**Re: KIA response to TMAC's response on TMAC's Hope Bay Project 2018  
NWB Annual Report.**

## Hope Bay Project 2018 NWB Annual Report

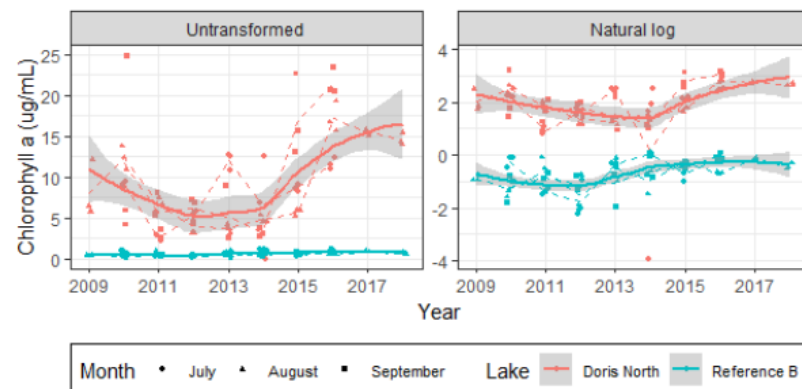
Regarding chlorophyll, although the trend in Doris Lake appears to increase over time, the evidence suggests that a similar change was evident in Reference lake B, as there is no statistical evidence of a differential trend in chlorophyll over time in these lakes. Therefore, the increase was concluded to be unrelated to the Project. It is difficult to see the trend in Ref B in the graph presented in the main report (see left panel below), but Appendix B of the 2018 AEMP Report shows the untransformed data alongside the log transformed data (see right panel below), and the similarity in trends is much more evident in the log-transformed graph.

<b>Review Comment Number</b>	KIA-NWB-24
<b>Subject/Topic</b>	Water quality
<b>Recommendation/Request</b>	Please note the additional parameters for future reporting.
<b>TMAC RESPONSE TO KIA-NWB-24</b>	<p>All evaluated water quality parameters including those noted above (turbidity, boron, iron, chromium) are being watched closely and will continue to be watched closely through the AEMP.</p> <p>The evaluation of effects methodology is based on both statistical analysis and graphical of trends over time, and trends between the reference and exposure sites. For turbidity and boron, based on a visual examination of the trends (graphical analysis), the discussion provided in the 2018 AEMP does state that concentrations of these parameters appear to have increased slightly over time in Doris Lake (at least over certain years), but the statistical analysis reveals in both cases that these potentially increasing trends are not significantly different from the</p>

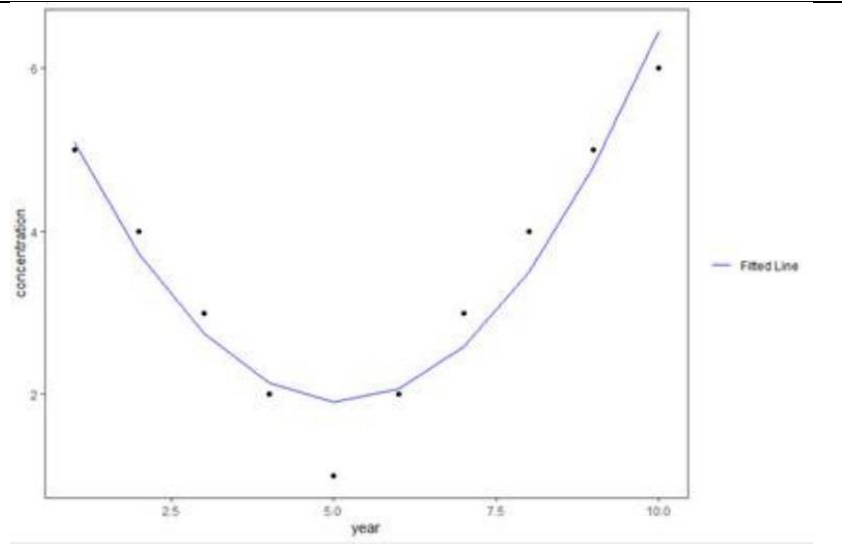
<b>Review Comment Number</b>	KIA-NWB-25
<b>Subject/Topic</b>	Water quality
<b>Recommendation/Request</b>	Please provide additional rationale about why Linear Mixed Effects model is the appropriate statistical test for water quality changes.

<p><b>TMAC RESPONSE TO KIA-NWB-25</b></p>	<p>A linear mixed effects (LME) model is an extension of the linear regression model with the addition of random effects. A LME model was used to account for potential sources of random variation, such as those that affects all measurements in all lakes in a given year. As mentioned in the methods section on random variation:</p> <p>“Random sources of variation can affect variable measurements. Potential sources of variability include environmental factors affecting all lakes equally in a given year, sampling variation that affects samples taken from a lake in a single year, and true measurement errors from laboratory analysis. The main sources of variation can be broken down into two components: yearly effects that affect the measurements in all lakes and effects that affect each lake individually. Random effects are included in the LME model to account for these sources of variation.”</p> <p>A linear model is “linear” in its model parameters, and not in the trend that it fits. For</p> <p>example, a simple linear model can be expressed as:</p> $Y = B_0 + B_1X_1,$ <p>Where Y is the response, B<sub>0</sub> is the intercept, B<sub>1</sub> is often called the slope term, and X<sub>1</sub> is the explanatory variable (for example, time). In this model, the trend is linear and monotonic. However, higher order terms (for example, squared or cubed) can be included to describe non-linear trends. For example, if time was also included as a squared term in the form:</p> $Y = B_0 + B_1X_1 + B_2(X_1^2).$ <p>This model produces the fit shown below:</p>

Therefore, a linear model is not constrained to capture monotonic linear trends.

Depending on the model setup, step-wise trends and curvi-linear trends may also be characterized.

The LME model used in the 2018 AEMP utilizes splines to capture trends over time. Splines do not constrain the trends to straight lines or monotonicity. For non-linear trends, spline fits provide a better characterization of the trends over time and capture more of the fluctuation shown in the data. If the data were suggesting step-wise or non-linear trends, the splines would show indication of such patterns.
